JVC Service Bulletin

DATE : Nov. 27, 1997

SUBJECT :It may not work AUTO CH PRESET.

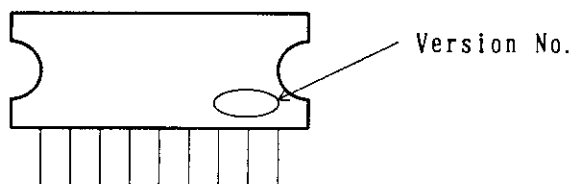
Please conform the IC's version(refer to following) when change this IC(TDA8350Q).

- ① In case of Version 3
 Change the C402 from 100pF to 4700pF(QCY31HK-472AZ).
- ② In case of Version 4 or Version 5
 Change the IC only.
